**RECALL CAMPAIGN
INSTRUCTIONS**

REF. NO. C24100080

**REPLACEMENT OF BRAKE FLUID
RESERVOIR CAP**

MODEL YEARS 2019 - 2020

Page Location to Apply
New Adhesive Sticker

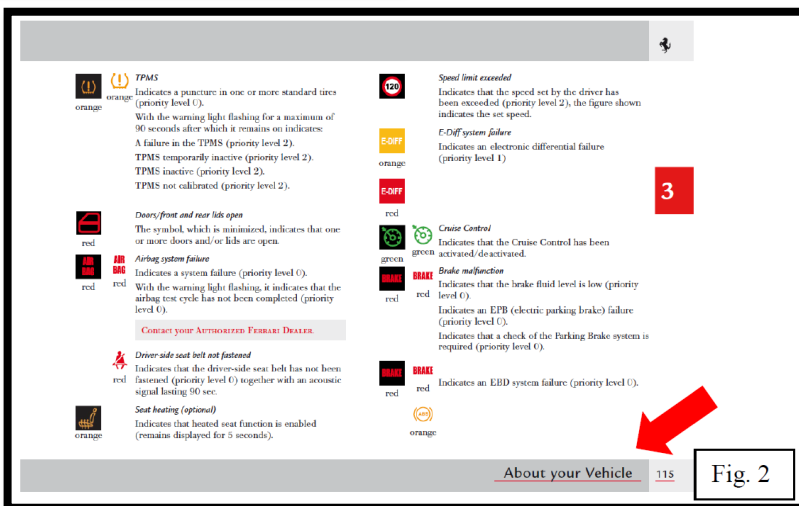
Please find below the proper location and instructions on how to insert the provided sticker into the Owner's Manual (PN: 079641778)

The sticker must be placed on the page shown above in the Owner's Manual. This page is located in the **"About Your Vehicle"** section where the warning lights on the instrument panel are described. Please be sure to attach it to the page with the **"Low Brake Fluid"** description as shown above in Fig. 2.

Once you locate the proper page, remove the adhesive protector off of the back of the sticker. Ensure there is no residue or other particles on the page that may inhibit the longevity of adhesion to the page. Place the sticker to allow the bottom of the sticker to lay directly above the gray margin at the bottom of the page that contains the text **"About your Vehicle"**.
